Groundwater Transfer Review Summary Form

Transfer/PA # T- 13675

Application: T-13675

Applicant Name: J-S Ranch

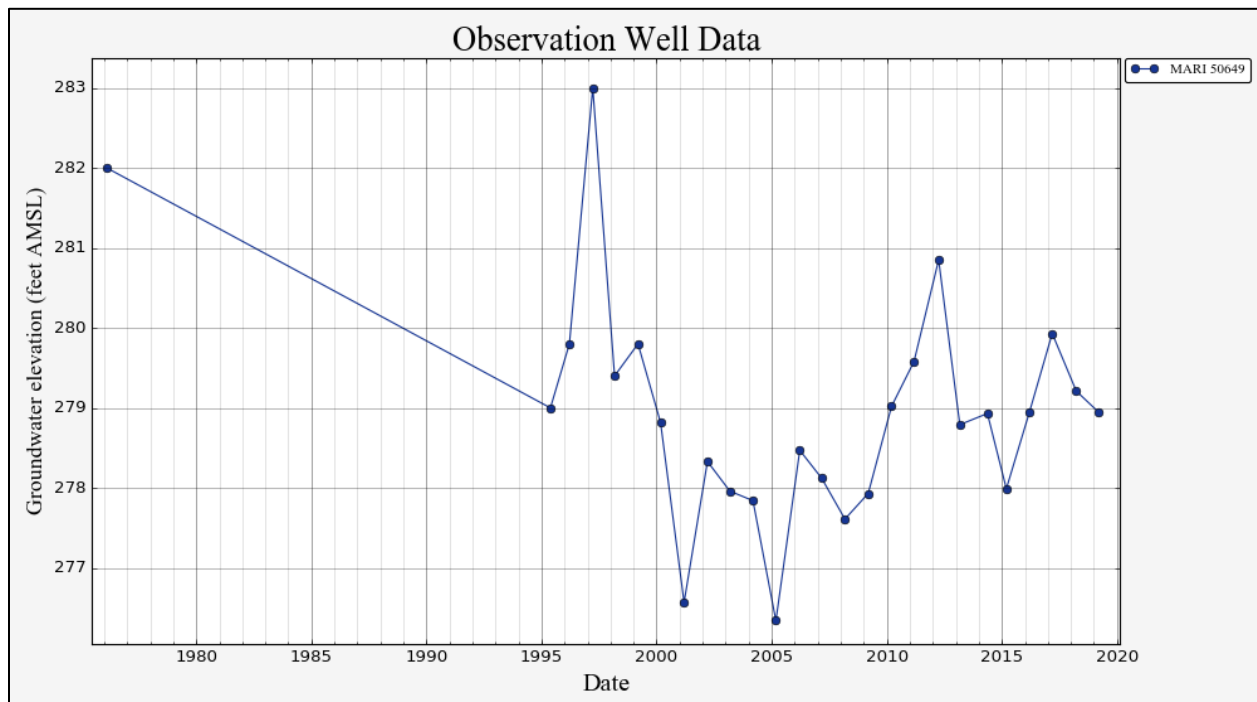
Provide context for minimal/significant impact: The proposed APOA well is not measurably closer to the North Santiam River than the existing authorized POA.
